Product Change Notification / NTDO-01ZZMF149

CCB 4673 Final Notice: Qualification of MTAI as additional assembly site for selected SY56040A, SY5803xU, SY58040U, SY8911xU, SY8946xU, SY89540U and SY89859U Micrel device families available in 44L VQFN (7x7x0.9mm) package.

Pre and Post Change Summary
PCN #: NTDO-01ZZMF149

Lead-Frame Comparison

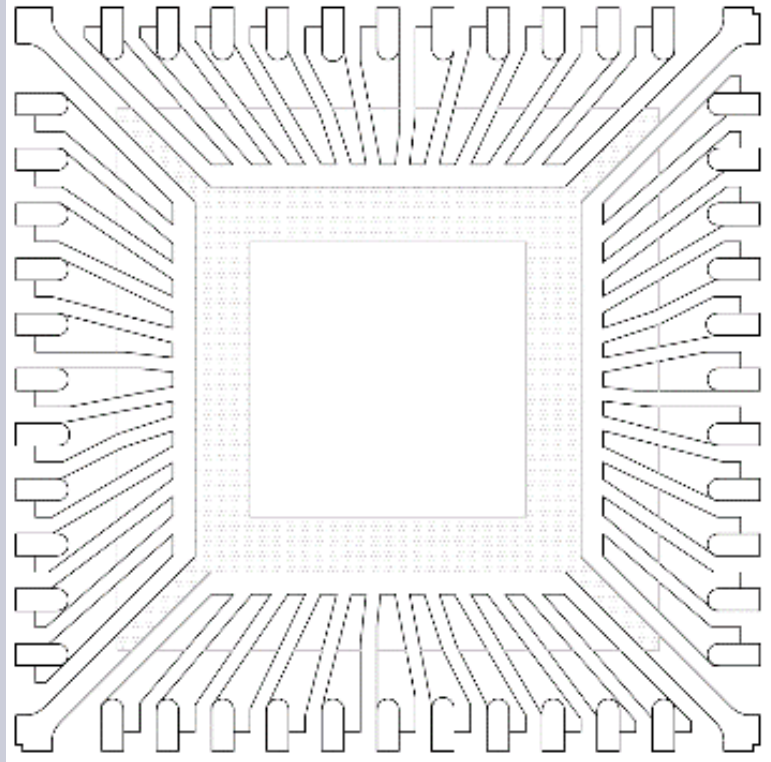
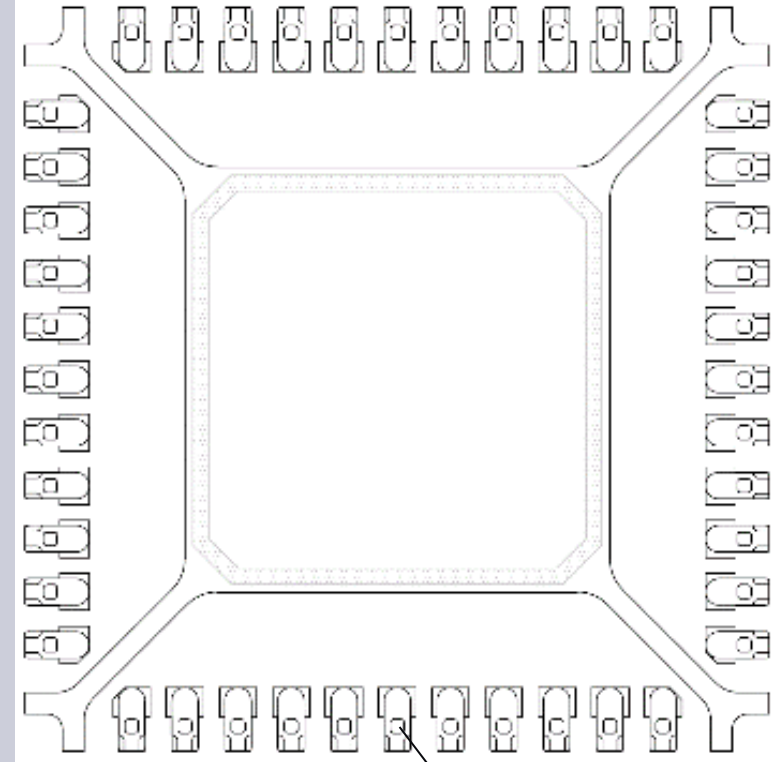
Lead lock

Note: The lead lock hole fills with mold compound during the assembly process and provides improved protection against moisture penetration around the interface edges between pins and mold compound.
